Network Working Group
Internet-Draft
Intended status: Experimental
Expires: August 14, 2018

TCP ~~option~~ Option "request IPv6 connection"
draft-rosenau-request-v6-option-00

Figure 3: IPv6 negotiated

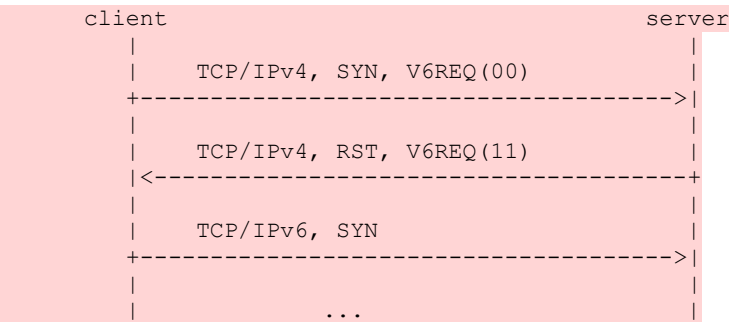
Commentaire [Med8]: This assumes that the option is not striped by a middlebox and not manipulated by a misbehaving node.

Commentaire [Med9]: Why not using MPTCP to signal this?

You can refer to that spec for more details why advertising an address may be a complex task than expected.

Commentaire [Med10]: This will lead to an extra delay to establish the session.

Figure 4: Using with NATs

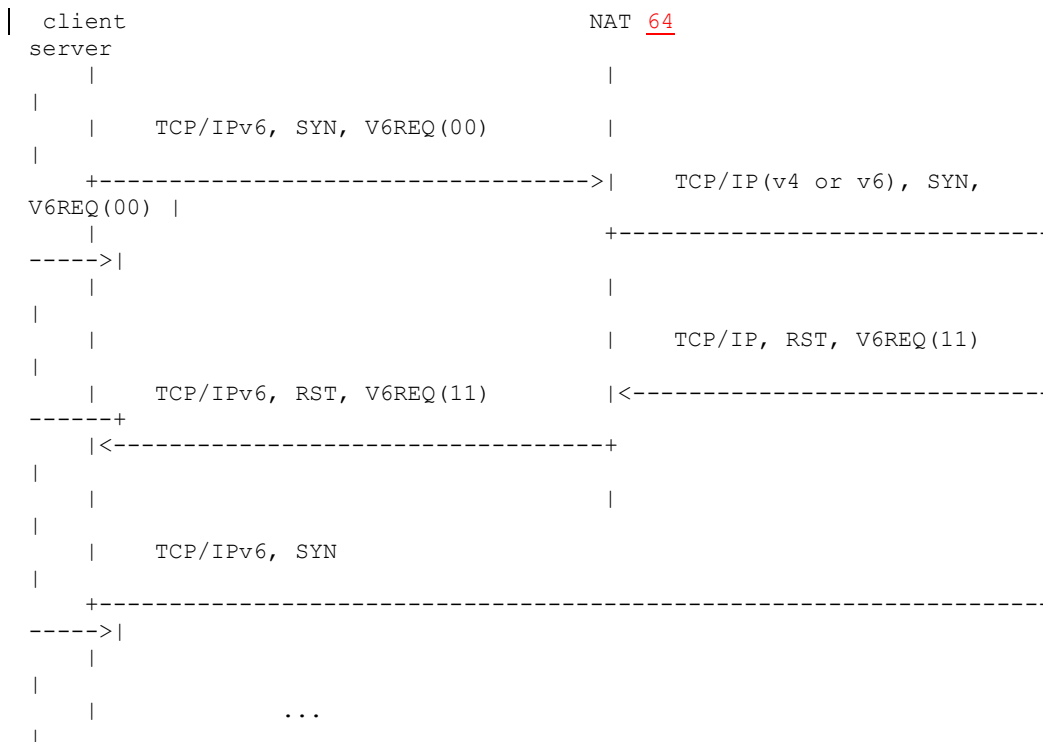
Commentaire [Med11]: If the server supports IPv6, why the client didn't use that address at the first place?
